**Addendum No. 1**  
**Specifications and Construction Documents**  
*McNeese State University*  
*Contraband Bayou Erosion*  
*Retaining Wall Phase II*  
**FP&C No. 19-627-12-03, Part 01 (F.19001093)**  
**Site Code 5-10-004**  
**M.A. Project No. H1-13015-DA**  
**June 4, 2020**

The following changes, additions, deletions, or alterations to the Specifications and Construction Documents and/or Contract Drawings shall be incorporated into the Specifications and Contract Documents and/or Contract Drawings for the above captioned project:

CONTRABAND BAYOU  
 EROSION RETAINING WALL PHASE II  
 CONTRACTOR MATERIALS STORAGE AREA  
 FIGURE NO. 1

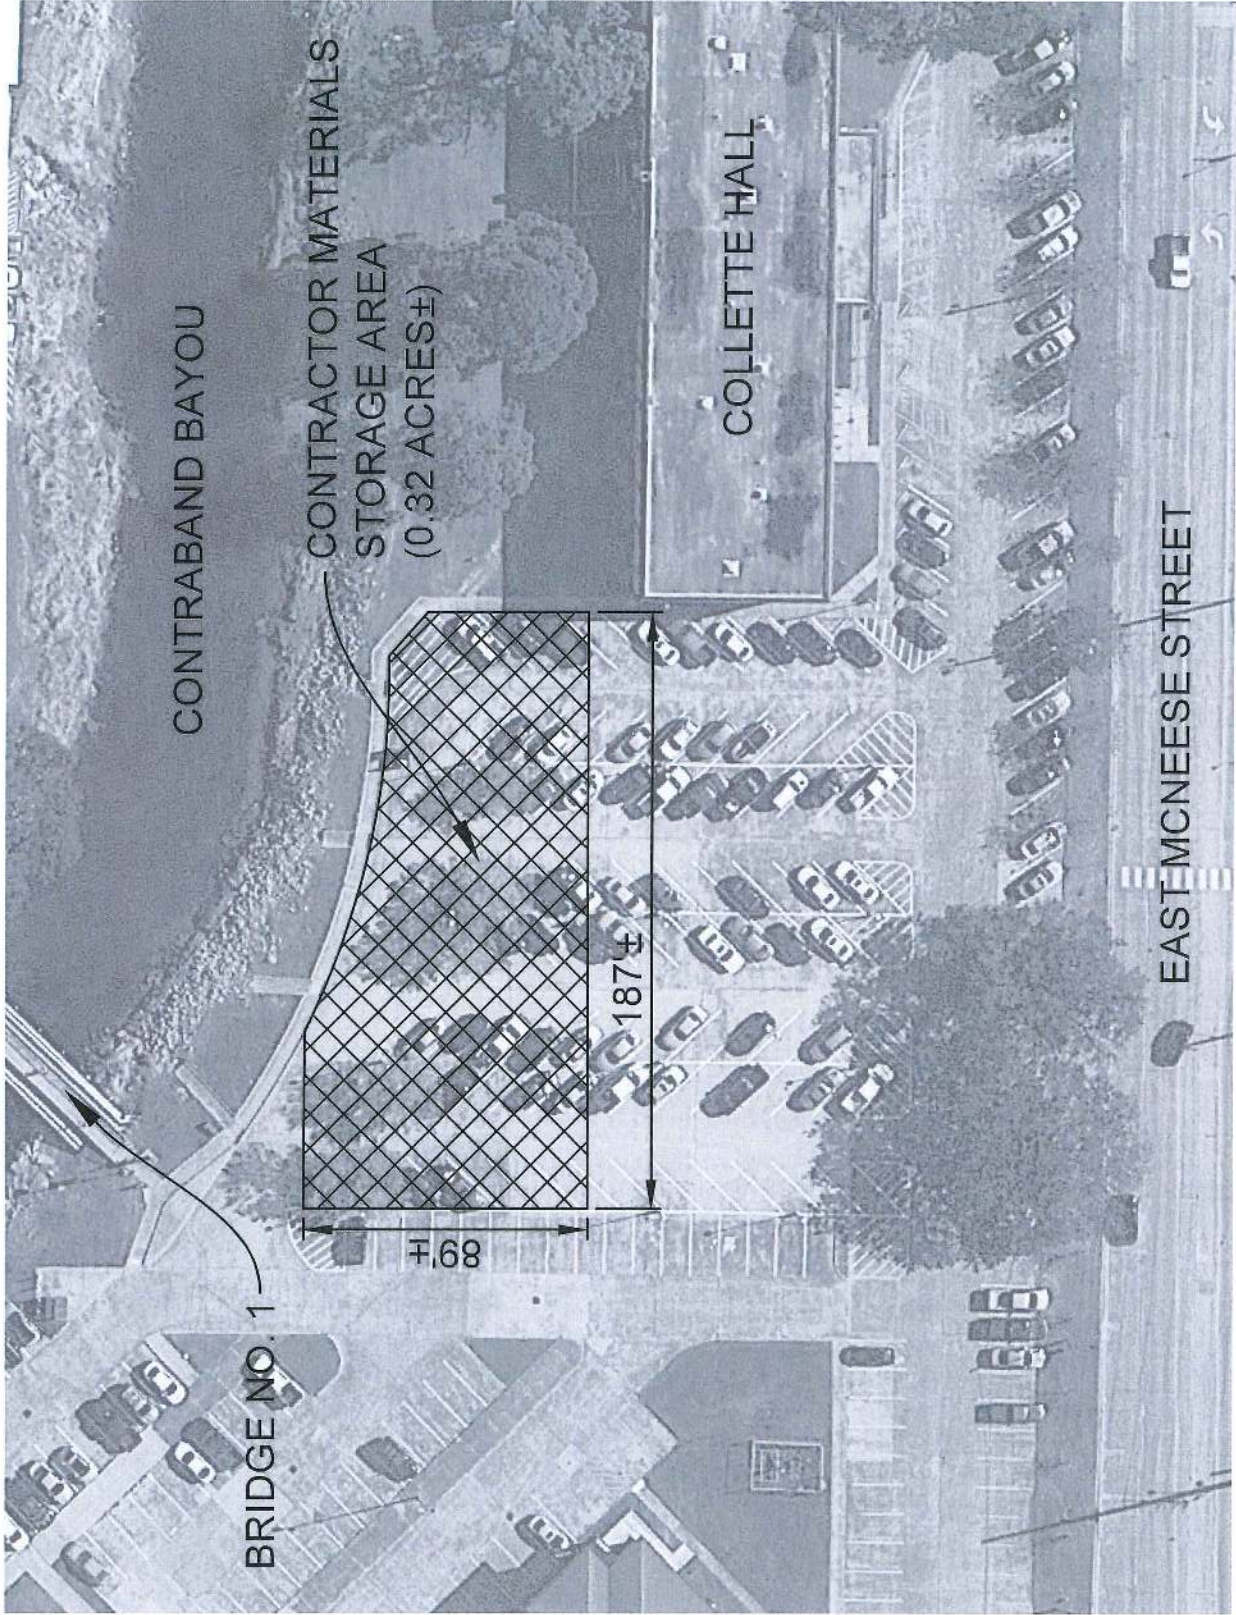
McNeese State University will provide the Contractor with a paved materials storage and staging area approximately 0.32 acres in size located north of McNeese Street and west of Collette Hall as shown on attached Figure No. 1.

The Contractor shall be responsible for temporary fencing along the perimeter of the area as required for security purposes. Upon completion of the project the Contractor shall return the area to the Owner in its original pre-construction condition.
